RE: Stacked Stone Retaining Wall  
146 Ambersham

PROJECT NO:	23002	PROJECT <b>146 AMBERSHAM</b>
DRAWN BY:	CRF	
REVIEWED BY:	CRF	
DATE:	01/10/2023	
		SHEET <b>RW1</b>

1 WALL SECTION  
3/8" = 1'-0"

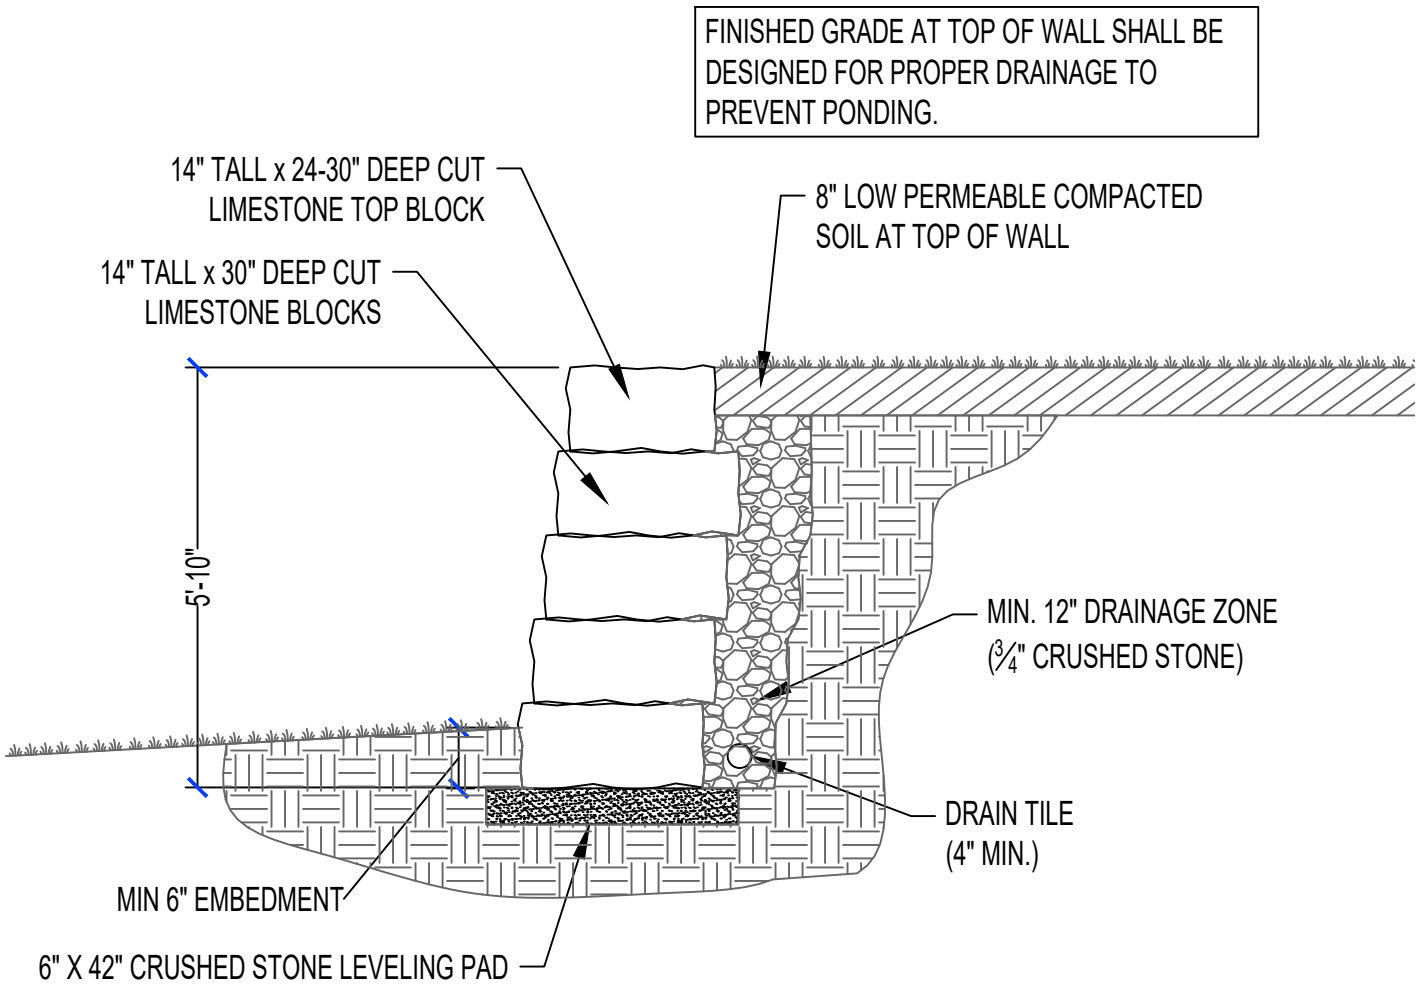
Per your request, Hart Creek Engineering has reviewed the construction of the retaining wall at the residence location at 146 Ambersham in Lee's Summit, MO. The wall construction appears to be in conformance with the attached wall details and built per industry standards.
